SUBJECT: ARKANSAS NUCLEAR ONE, UNIT 2 (ANO-2) - RELAXATION REQUEST
FROM U.S. NUCLEAR REGULATORY COMMISSION (NRC)
ORDER EA-03-009 FOR THE CONTROL ELEMENT DRIVE MECHANISM
(CEDM) NOZZLES (TAC NO. MC8282)

SAFETY EVALUATION BY THE OFFICE OF NUCLEAR REACTOR REGULATION
RELAXATION REQUEST FROM ORDER (EA-03-009)
ESTABLISHING INTERIM INSPECTION REQUIREMENTS FOR
REACTOR PRESSURE VESSEL HEADS AT PRESSURIZED WATER REACTORS
ARKANSAS NUCLEAR ONE UNIT 2
DOCKET NUMBER 50-368

Figure 1

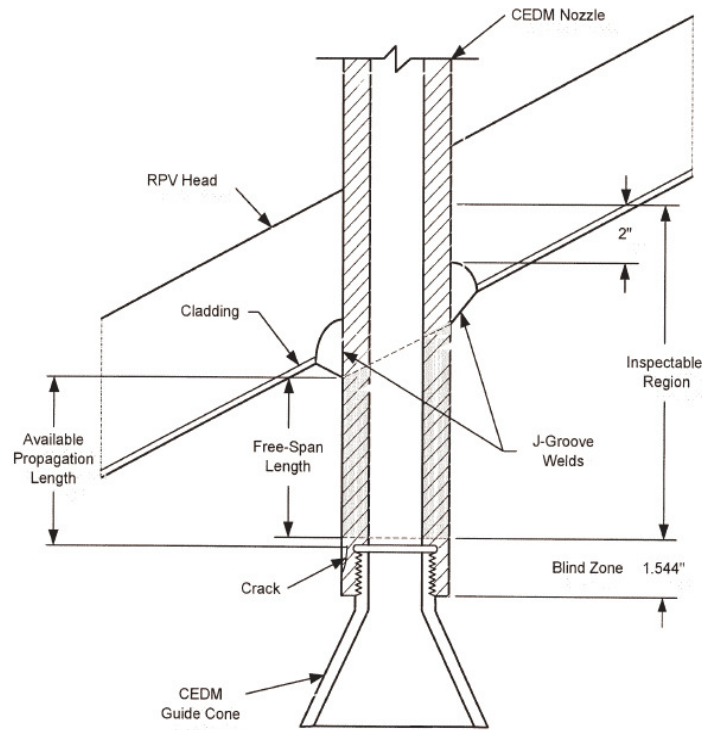
The licensee states that the ID of each control element drive mechanism (CEDM) nozzle (i.e., nozzle base material) shall be UT examined from 2 inches above the root of the J-weld (on a horizontal plane perpendicular to the nozzle axis) to 1.544 inches above the bottom of the nozzle. The licensee will also perform an assessment to determine if leakage has occurred into the interference fit zone, as currently specified in Section IV.C.(5)(b)(i) of the Order. Figure 1 of this safety evaluation (SE) is from the licensee's submittal and shows the inspection areas of a CEDM nozzle as defined by the licensee.

According to the licensee, meaningful UT data cannot be collected in the threaded area or the chamfer region. The chamfer region geometry causes sporadic signals while, once the guide cone is reached, sound cannot pass into the CEDM nozzle base material because of the gap that exists between the guide cone and the nozzle at the threaded connection. This leaves a length of 1.344 inches ($1.25 + 0.094$) at the bottom of the CEDM nozzle that cannot be inspected by UT examination due to nozzle configuration.

In addition to the limitations of inspecting the chamfer and threaded area of the bottom of the CEDM nozzles, there are limitations regarding the inspection probe's ability to collect data 0.2-inch above the chamfer area. The inspection probe that is to be used for the ANO-2 CEDM nozzles consists of seven (7) individual transducers. The transducers consist of one pair used for circumferential scanning using time of flight diffraction (TOFD), one pair for axial scanning using TOFD, one standard zero-degree scan transducer, and two ECT transducers. These transducers are slightly recessed into the probe holder that must be filled with water to provide coupling between the transducers and the nozzle wall. The licensee states that prior UT examinations performed on the CEDM nozzles at ANO-2 indicate that the circumferential-scanning TOFD transducer pair only collects data down to a point 0.200-inch above the chamfer. This makes the total distance at the bottom of the nozzle that cannot be UT inspected equal to 1.544 inches (1.25 inch threads + 0.092 inch chamfer + 0.2 inch). This area is referred to as the "blind zone." The licensee knows of no UT equipment currently available that resolves the blind zone limitation and, therefore, new UT equipment would have to be developed and appropriately qualified. According to the licensee, the time and resources required to develop this equipment is unknown.

The staff concludes that the licensee's proposed alternative examination of the CEDM RPVH penetration nozzles using UT from 2 inches above the J-groove weld to 1.544 inches above the bottom of the CEDM nozzles, and the augmented examination of nozzles without sufficient free-span length, provide reasonable assurance of the structural integrity of the RPVH, VHP nozzles, and welds. Further inspection of the CEDM nozzles in accordance with Section IV.C.(5)(b) of the Order would result in hardship without a compensating increase in the level of quality and safety. Therefore, pursuant to Section IV, paragraph F of the Order, good cause has been shown for relaxation of the Order, and the staff authorizes, for the remainder of the current third 10-year inservice inspection interval, commencing with the start of the fall 2006 refueling outage, the proposed alternative inspection for all CEDM head penetration nozzles at ANO-2, subject to the following condition as stated in the licensee's submittal dated September 9, 2005:
